Subject: Suggestion for Draft 3

Summary

On page 155 of the plan, the "Zoning" column of the "Hub" row says "Amend D-1, D-2, and TC-1."

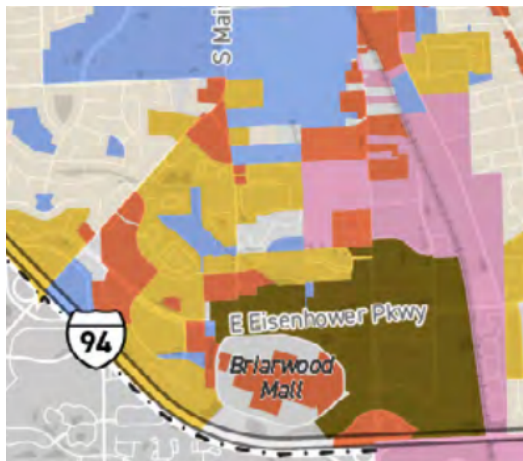
This recommendation is different than those of the other categories, which call for new zoning districts to replace old ones. I think creating a new Hub zoning district is going to be faster and better than amending and extending D1, D2, and TC1, so I suggest modifying that one box on the chart to read "Amend D-1, D-2, and TC-1, or create new mixed-use district(s)." This language will give the commission multiple options for implementing the Hub category.

Current Zoning with TC1 in brown

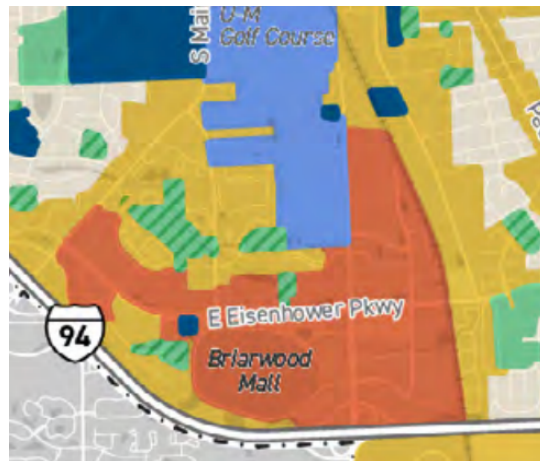
If you [compare](#) the future land use map with current zoning, you'll see that Hub covers areas that are not currently TC1, D1, or D2.

[Page 129](#) of the plan shows how many areas that are not TC1, D1, or D2, have been categorized as Hub.
